Moss Beach Evaluation 10/20/20 Meeting – Follow-up Notes and Resources

California and Highway 1

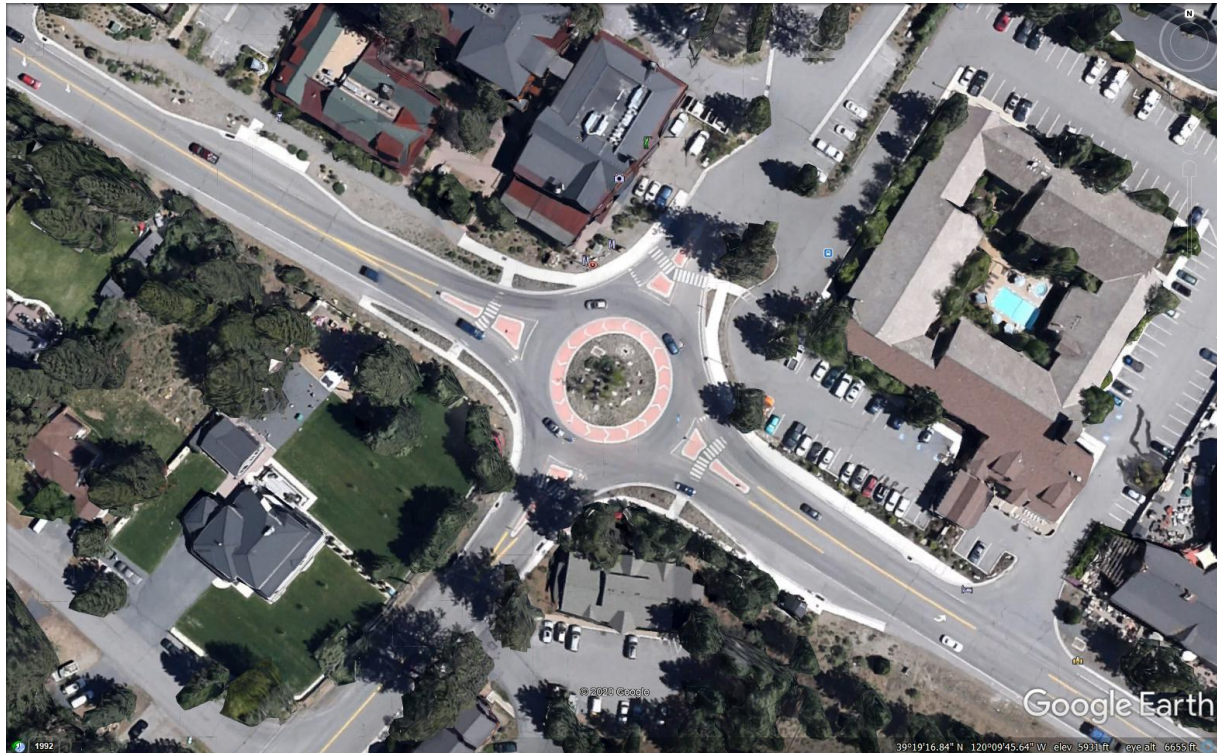
- Conceptual (10% designs) for signal and roundabouts do not appear to have fatal flaws; signal warrant analysis may not be appropriate mechanism for evaluating need for roundabout

- Address turning radius/access on Carlos, south of California Ave (roundabout), particularly for large trucks
- Traffic calming needed on SR-1 approaching the roundabout

- Orient crosswalks to increase visibility for people walking (roundabout)
- Square the signal crossing to shorten the crossing for pedestrians
- Evaluate options for direct Parallel Trail crossing at Carlos and SR-1, instead of routing away from intersection (roundabout)

- Dropping bike lanes from the roundabout design is appropriate
- Check the designs against the Caltrans Highway Design Manual to see if any exceptions are needed

- Evaluate signal performance with multi-lane approaches; recommend adding multi-lane approaches and downstream weave
- Address drainage concerns in area between Carlos St and SR-1, north of California Ave (red-legged frog habitat)

- Address left-turns for reoriented Wienke Way from northbound SR-1; left-turn bay into Wienke is likely possible with roundabout, not with signal
- Evaluate mitigation trade-offs regarding impacts to endangered species habitat

- Review opportunities to connect Wienke into roundabout, e.g., split Wienke terminus and allow southbound entry and incorporate connection from roundabout to Carlos Street (examples below)
